EPC STORMWATER REVIEW COMMENTS
IN ORANGE BOXES WITH BLACK TEXT

UDON SOUTH SITE DEVELOPMENT PLAN 12265 HIGHWAY 94

COVER SHEET

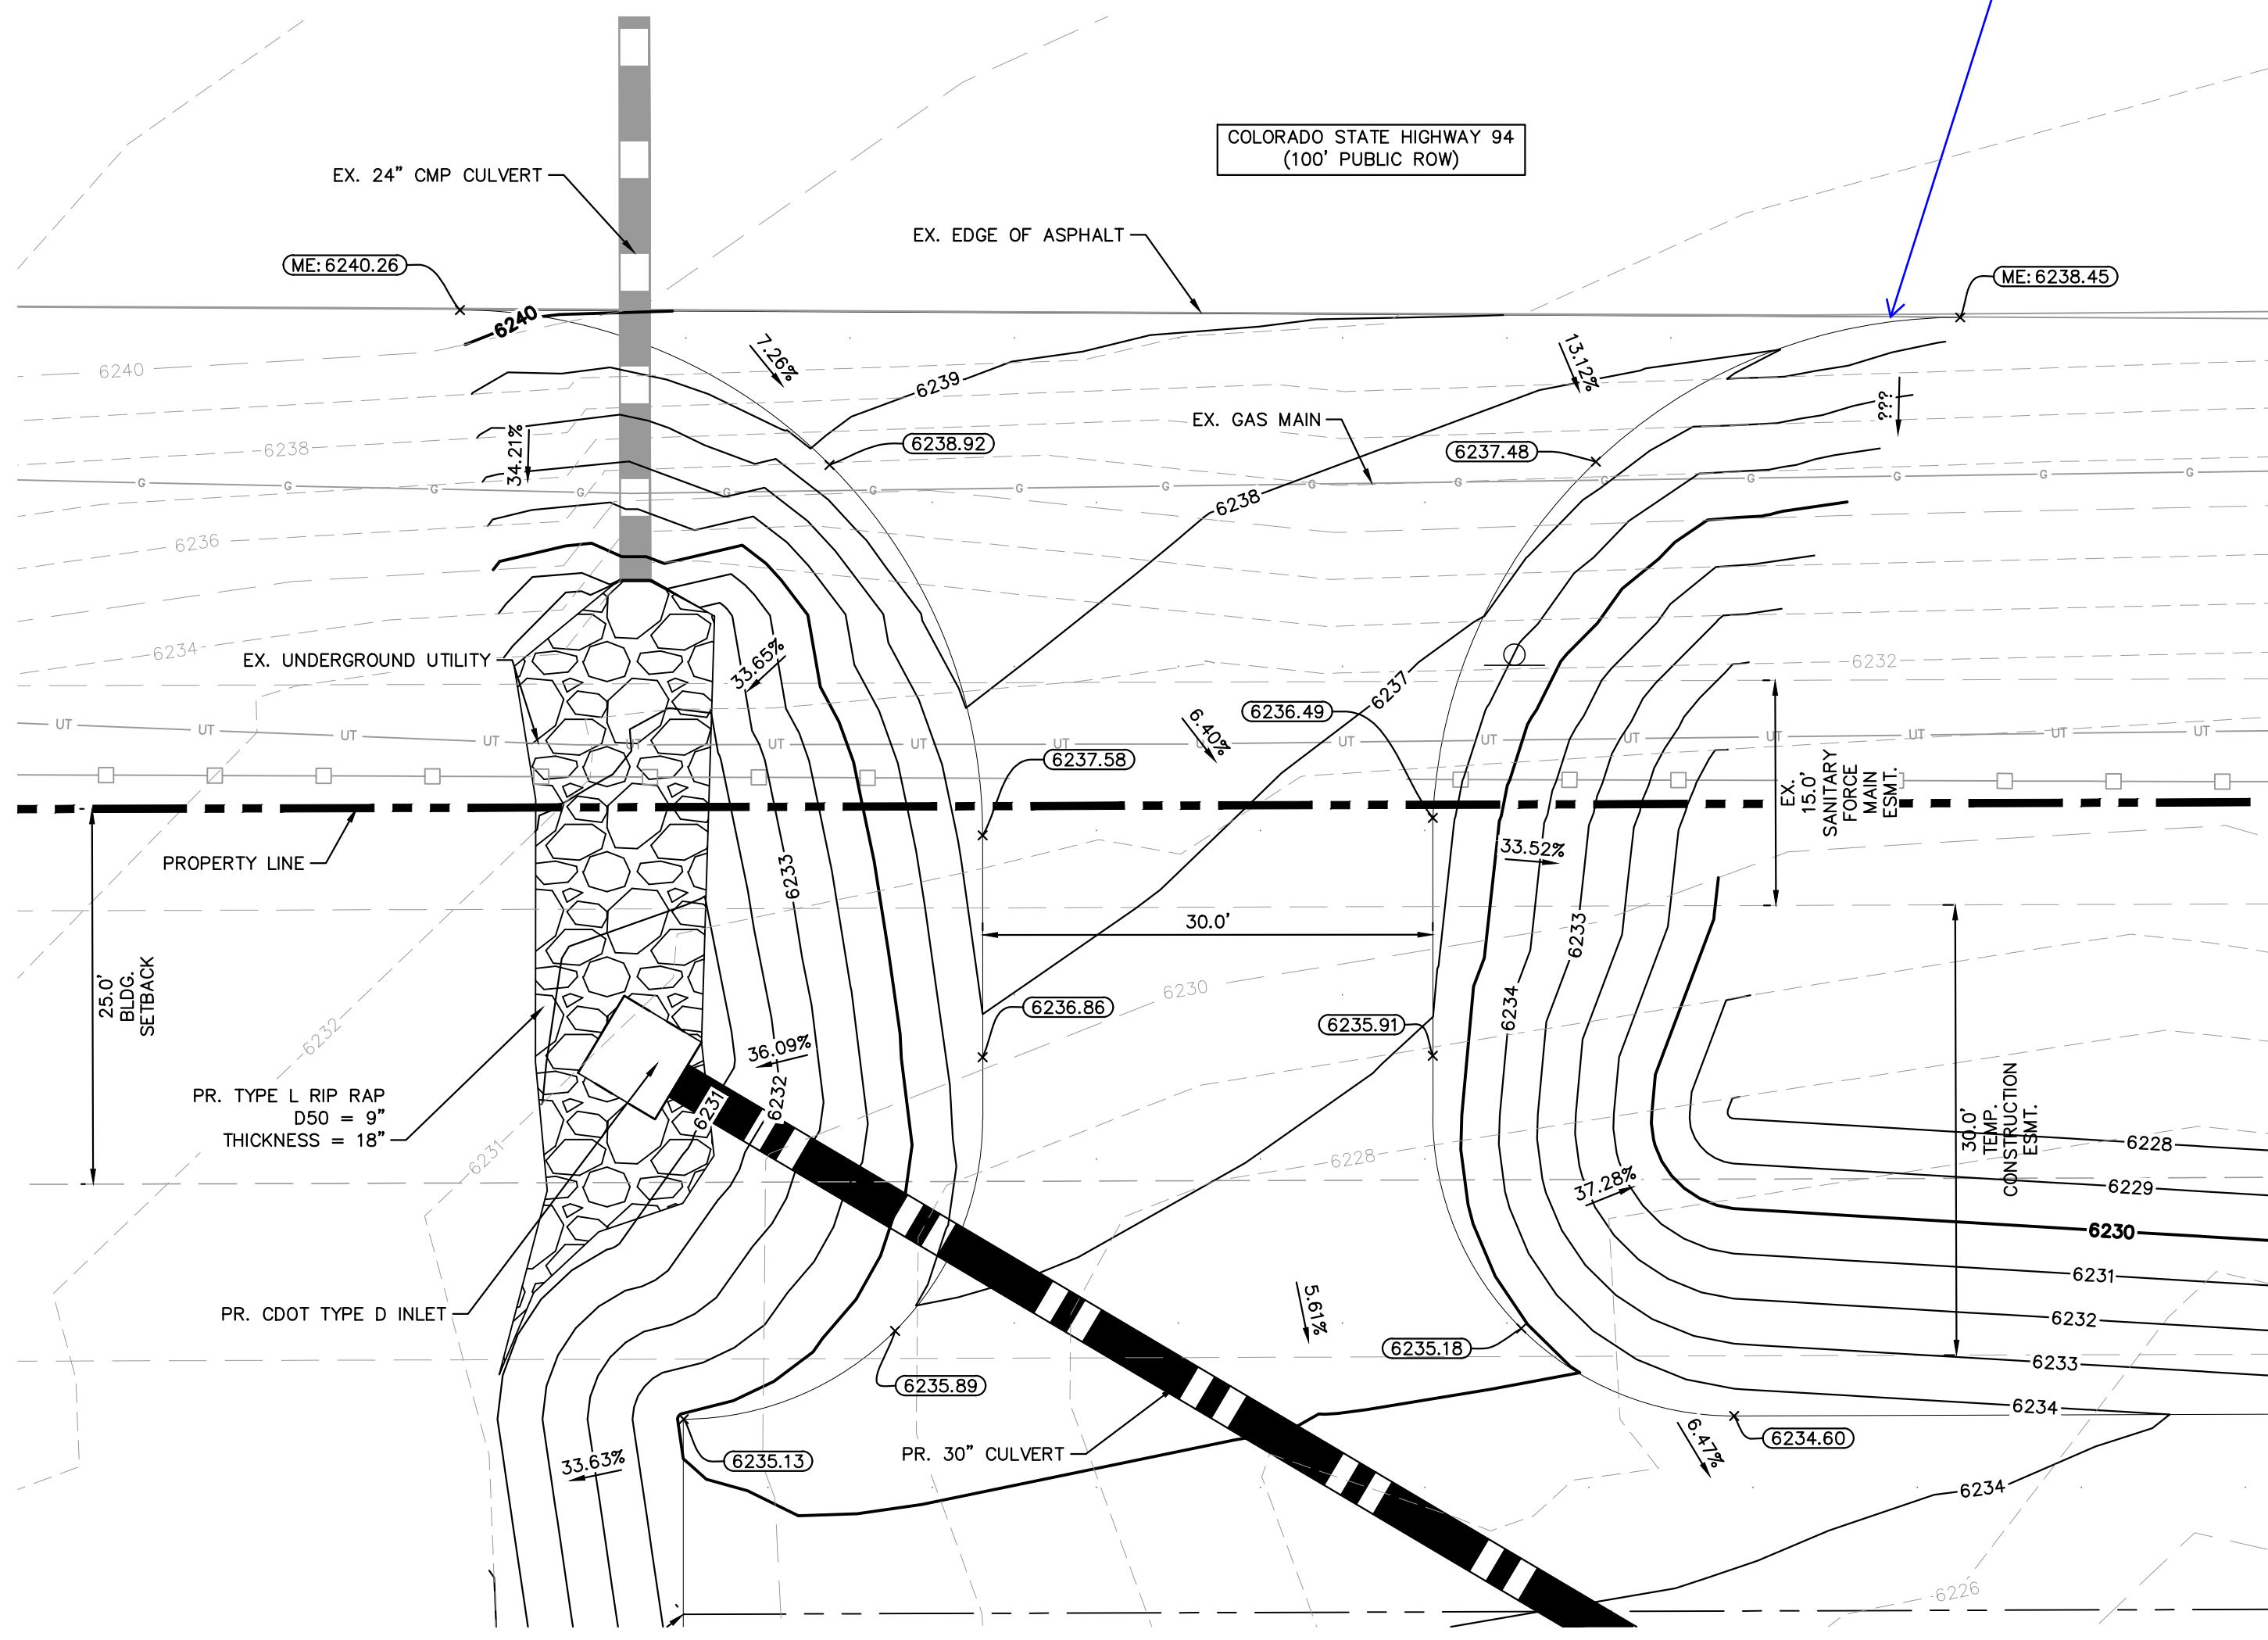
Coordinate with the Traffic Engineer so that recommendations can be provided for the turn radius of the Driveway for the proposed RV design vehicles. Auto turn exhibits should be provided.

Provide CDOT standard for access. This would be for a residential driveway to a local not a commercial access to an arterial/highway.

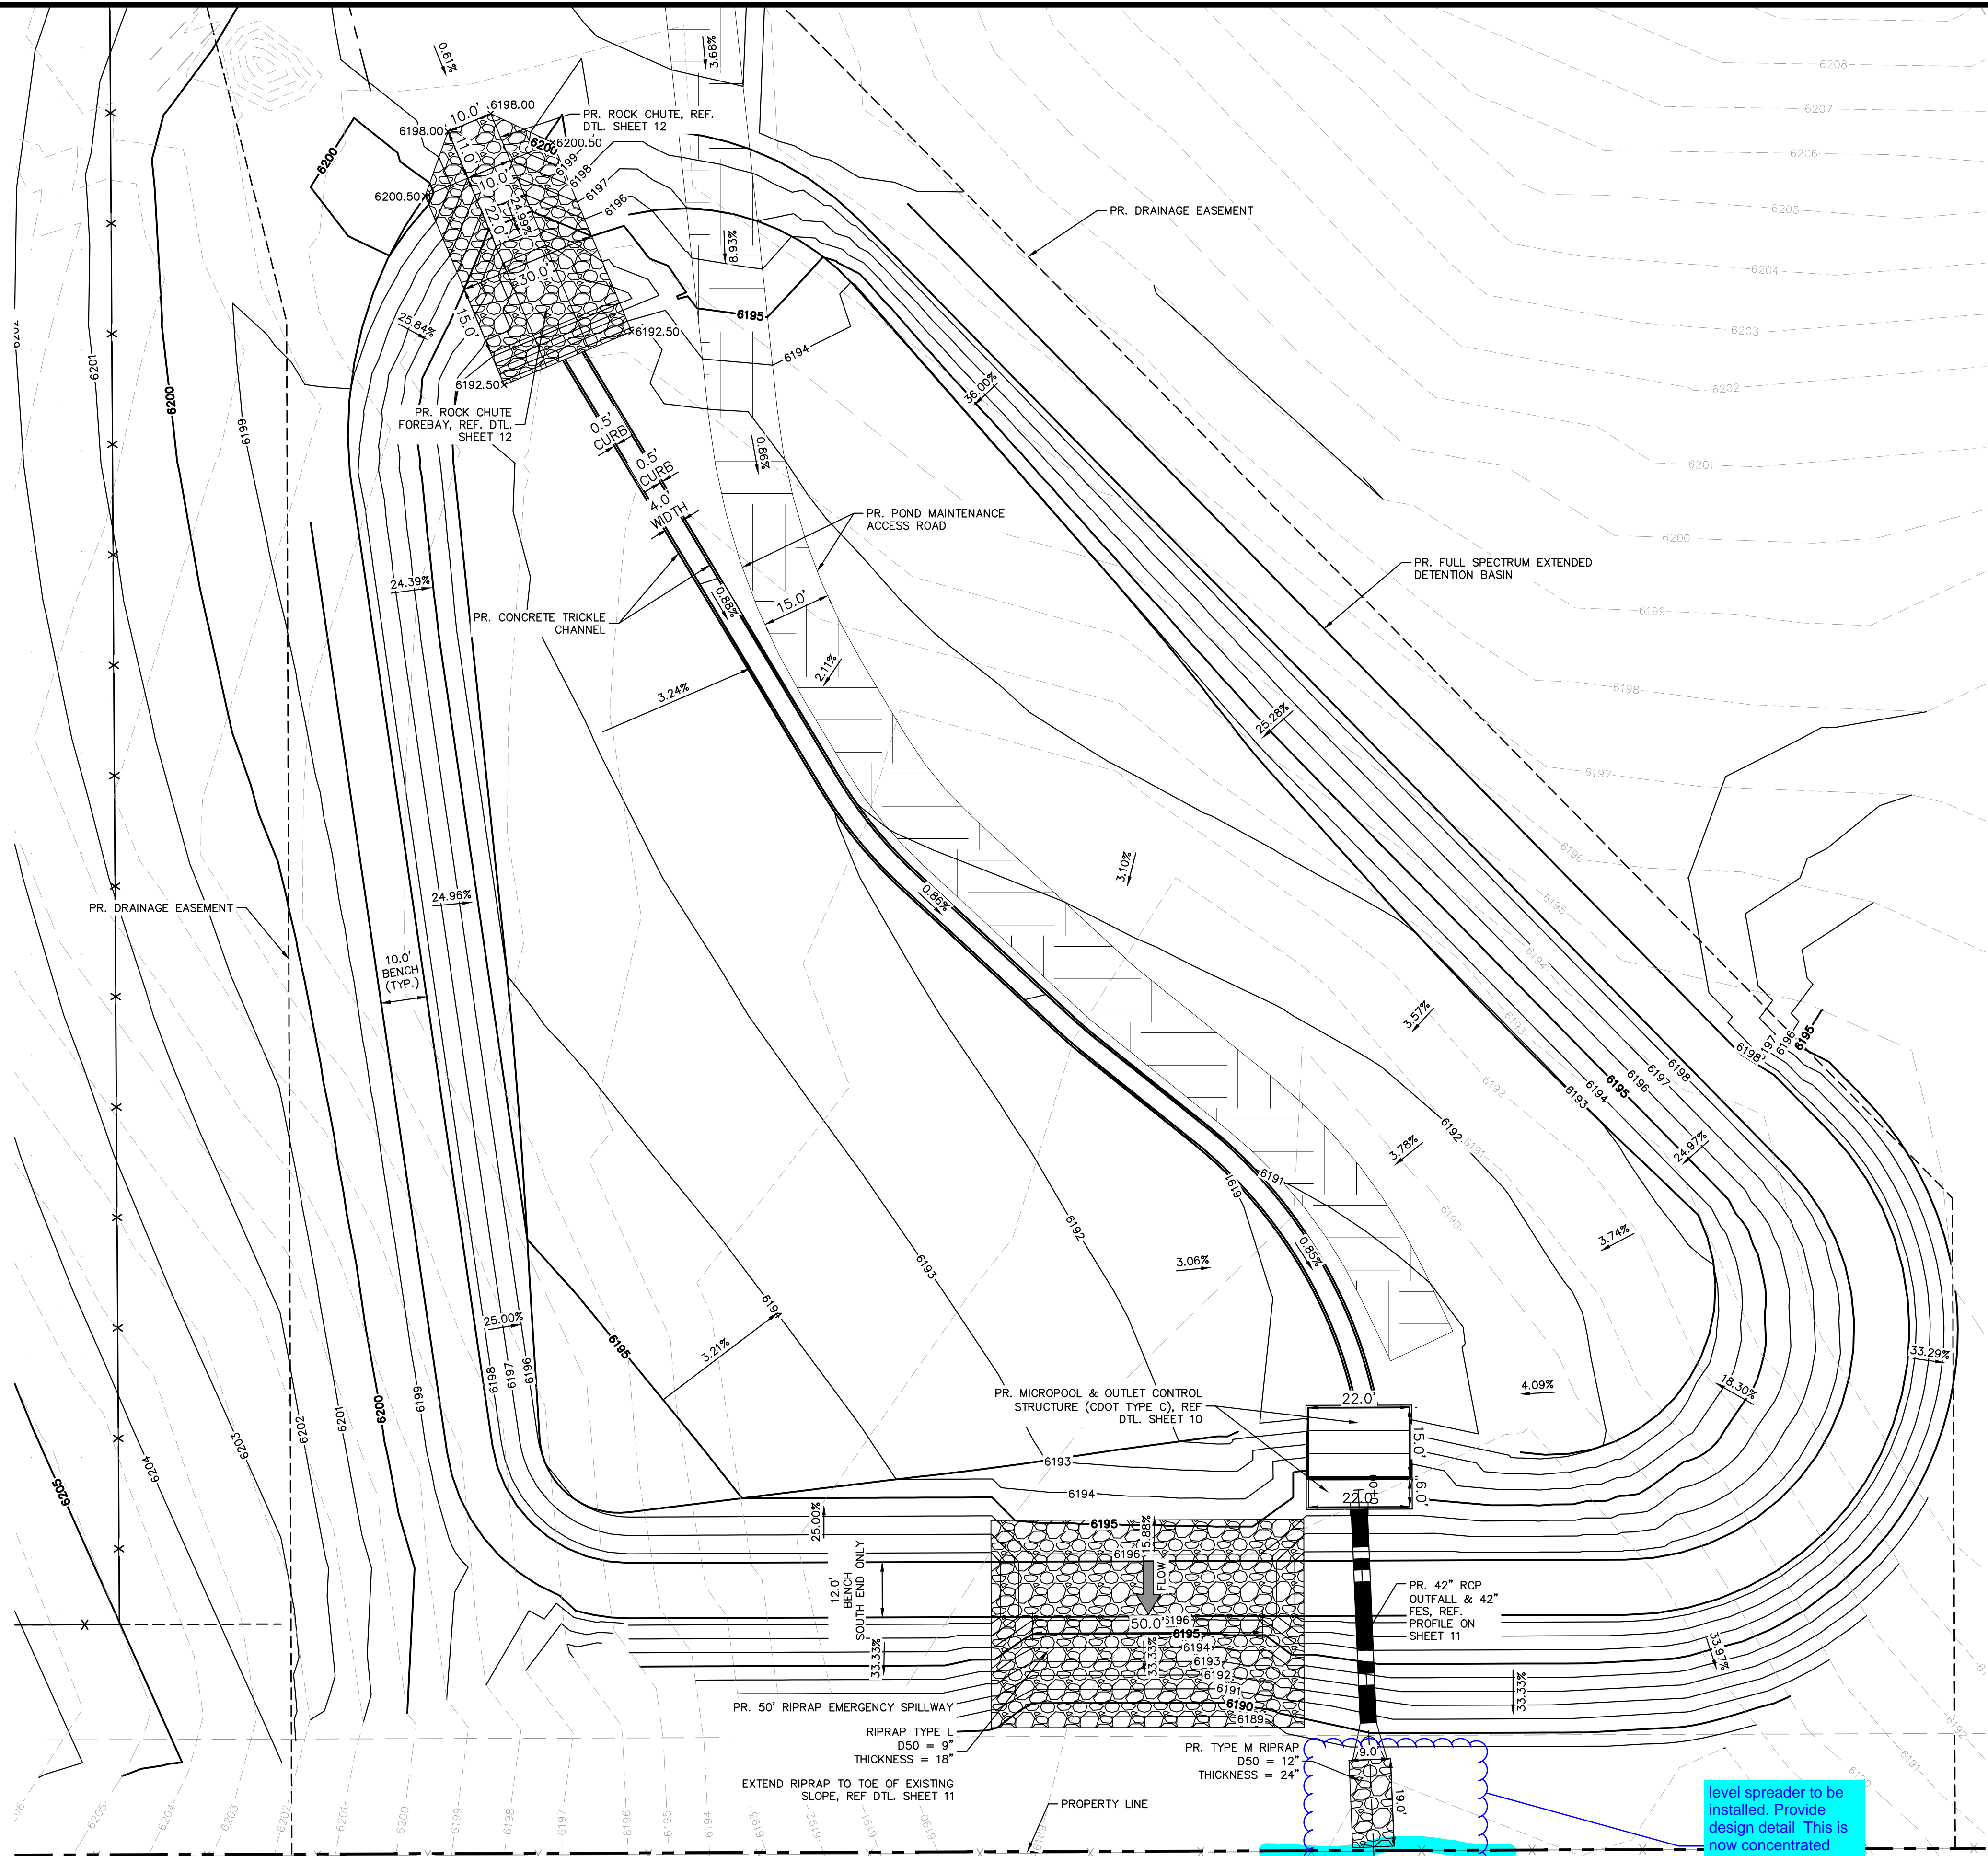
Since this pond isn't deeper than 10ft and doesn't meet other jurisdictional dam minimum criteria, submit Proof of Submittal for a State Non-Jurisdictional Water Impoundment Structure Notification.

level spreader to be installed. Provide design detail. This is now concentrated flow and point discharge. Update FDR

Typical Comment: Assign a name/number to all PBMPs and then update all submitted text and drawings accordingly with consistent labeling throughout (example: "Pond A" or "Pond 1").

ROCK CHUTE PROFILE - POND TRICKLE CHANNEL APPLICATION
1" = 5'

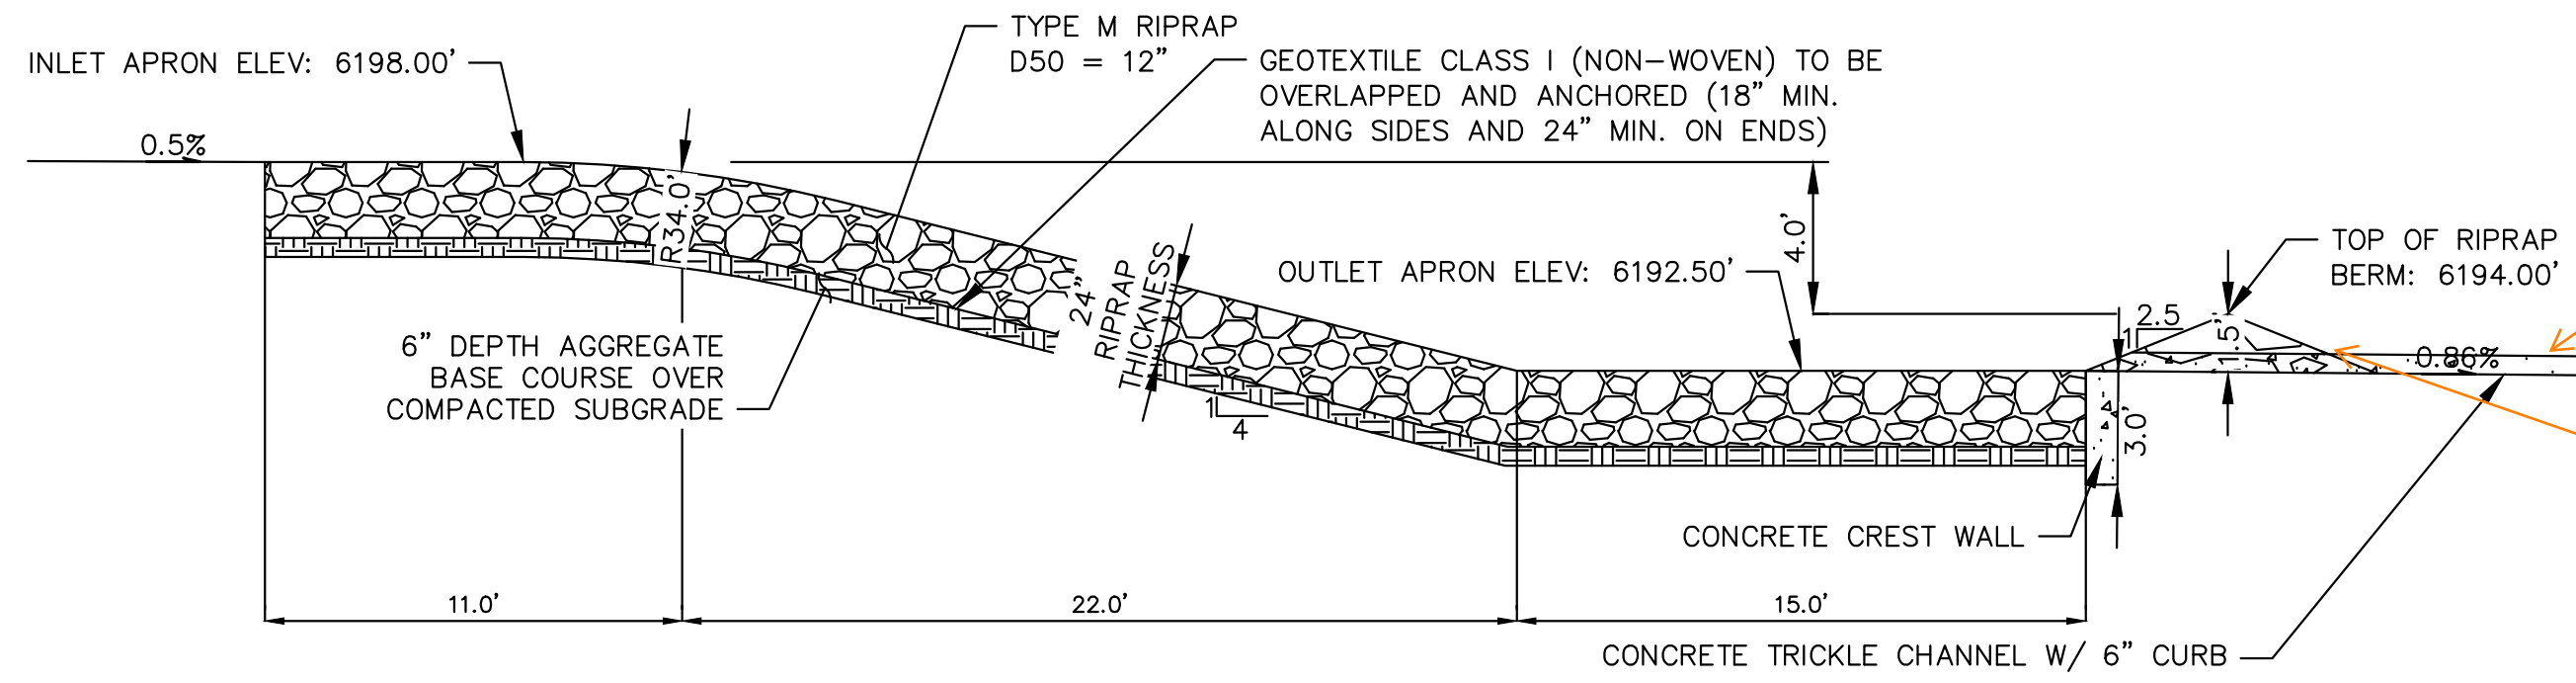
Where is the proposed grade in this interface? Clarify how this works and maintains a pond bottom slope of 3% to the top of the trickle channel.

These details do not match, please revise to remove discrepancy.

TRICKLE CHANNEL - TYPICAL SECTION
1" = 5'

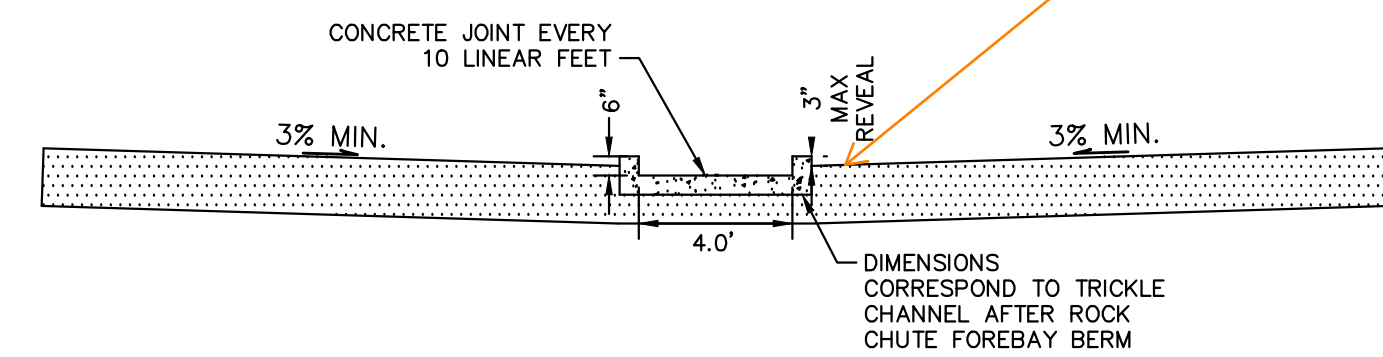
Adding a detail that shows the transition from forebay to trickle channel would be really helpful. Also, it would help to add a note and/or linework that shows the pond bottom throughout each detail here.

TRICKLE CHANNEL - PROFILE
1" = 5'

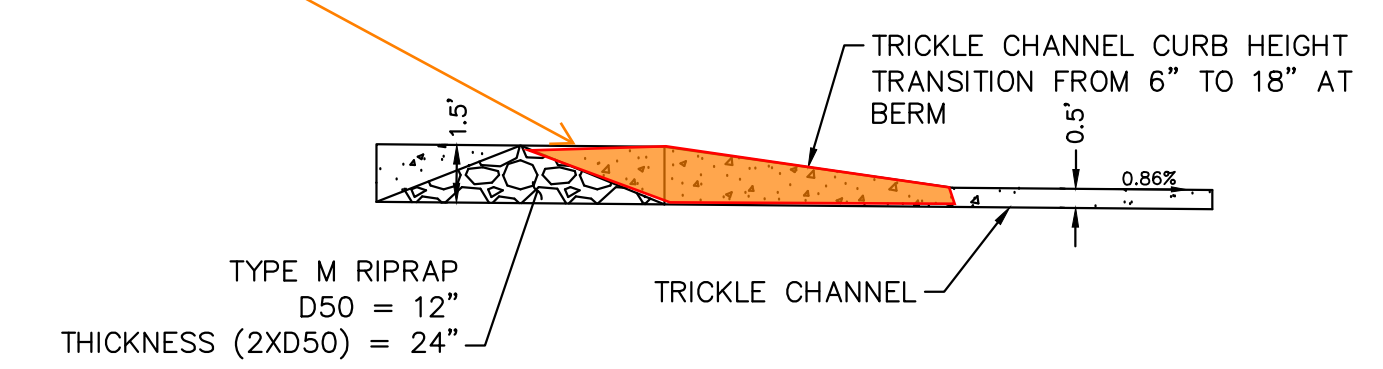
Pond bottom should meet the top of trickle channel to avoid erosion problems. We commonly see issues where if the pond bottom isn't graded correctly, erosion will continue along the full length of the trickle channel and the flow bypasses the trickle channel.
